TECH BULLETIN

079
3/99

SUBJECT: Manifold Head Change - 5PFR

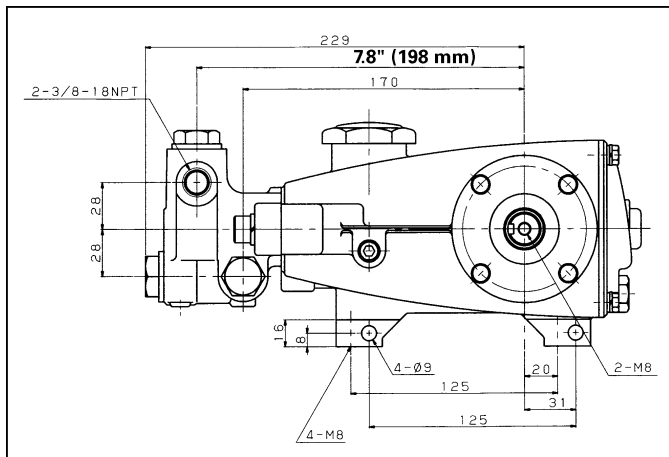
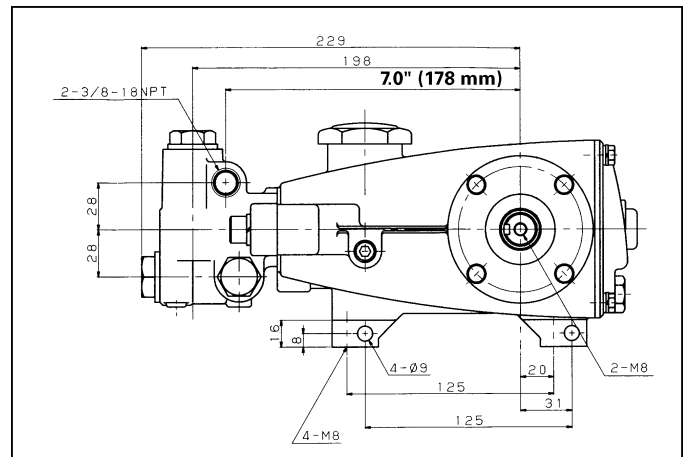
The tooling for the Nickel Aluminium Bronze manifold head has expired. In creating a new tool, the head is slightly modified and results in a relocation of the discharge port on the 317, 347, 357 pumps.

The center distance from discharge port to crankshaft is now 7.0" (178 mm) on all pumps from the March 1999 production forward. The Part Number (44124) for the manifold head will remain the same.

Prior to 399
Old Models

After 399
New Models
